**Staff Analysis of Proposed Amendment to the
Dane County Water Quality Plan,
Revising the Sewer Service Area Boundary and Environmental Corridors
in the Central Urban Service Area (City of Madison / Northeast Neighborhood)**

Map 9B – Proposed Stormwater Management

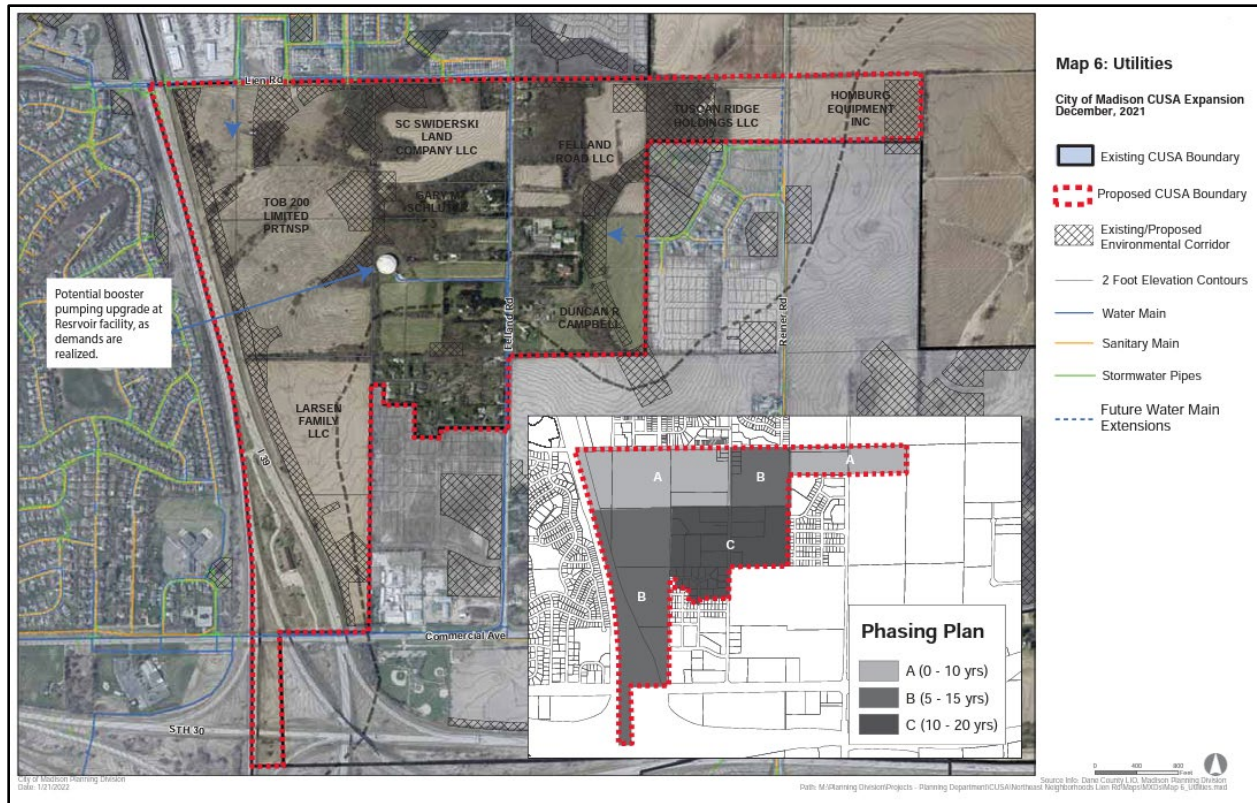
A public hearing was held on the proposed amendment at the March 10, 2022, meeting of the Capital Area Regional Planning Commission. City of Madison staff registered in favor of the amendment. There were no registrants opposed to the amendment. Commissioner McKeever

inquired about the specific location of the stormwater management facilities in the amendment area. There were no other questions from Commissioners.
